C•F•Z Group, LLC
Coltrane•Fernandez•Zavala
Landscape Architects
7410 John Smith, #208
San Antonio, Texas 78229
210-366-1911

ADDENDUM NO. 02

PROJECT NAME: McAllister Park
TCI PROJECT NO.: 40-00375
DATE: July 2, 2015

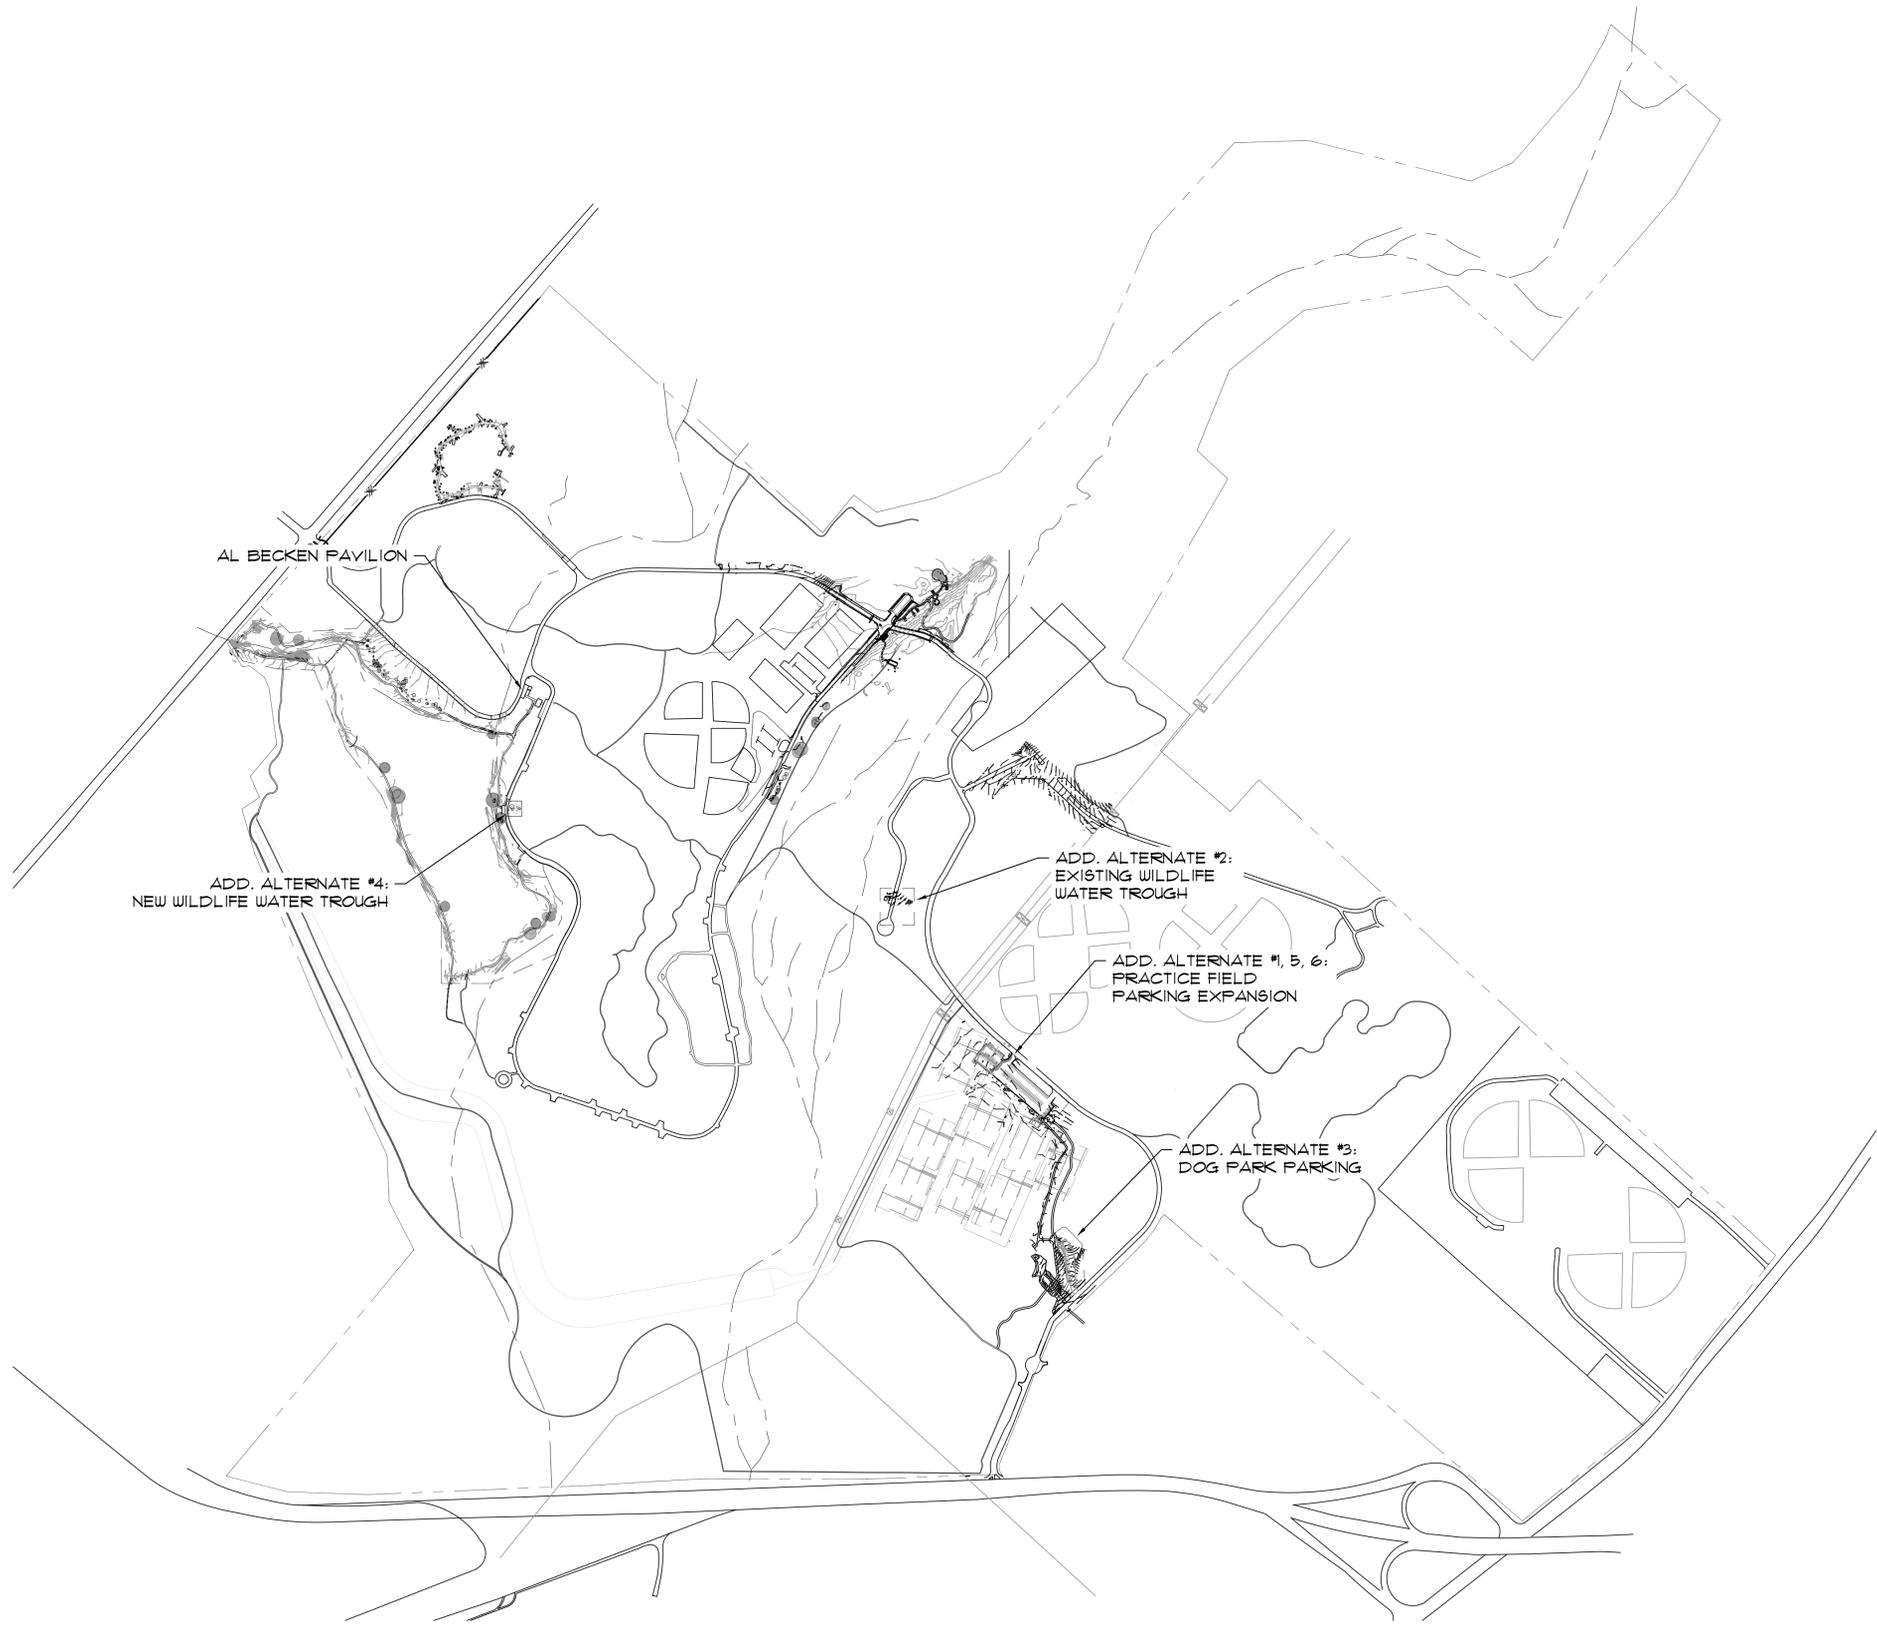
Response: Asphalt removed during demolition may be removed and disposed of or stored off-site at contractor's discretion. This applies only to asphalt. Any soil removed during demolition or construction is to be stored on-site and may not be removed from park boundaries. See attached revised sheet L1.0.

25. Asphalt removed during demolition may be removed and disposed of or stored off-site at contractor's discretion. This applies only to asphalt. Any soil removed during demolition or construction is to be stored on-site and may not be removed from park boundaries.
